Beckfoot School Accessibility Action Plan April 2023

4.1 - ACTION TABLE

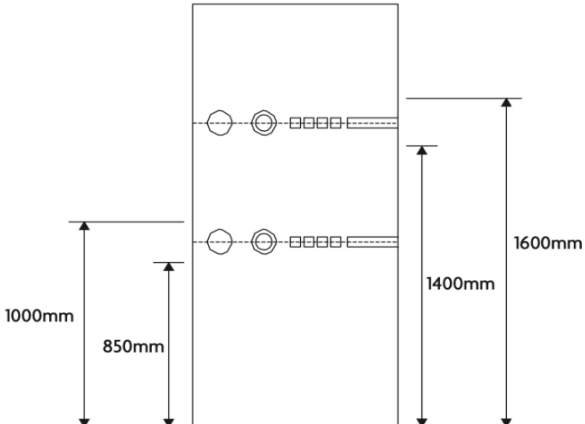
13.5	<p>High dispensers and mirrors were identified across various facilities.</p> 	<p>The tissue, soap and towel dispensers should be relocated at a height of between 800mm and 1000mm above finished floor level. Refer to BS8300 Figure 42 for guidance.</p> <p>Ideally, full-length mirrors should be present at a height between 600mm - 1600mm located away from the handbasin in accordance with BS8300.</p> <p>Height of drop-down support rails to be the same as the other horizontal grab rails.</p> <p>Key</p>
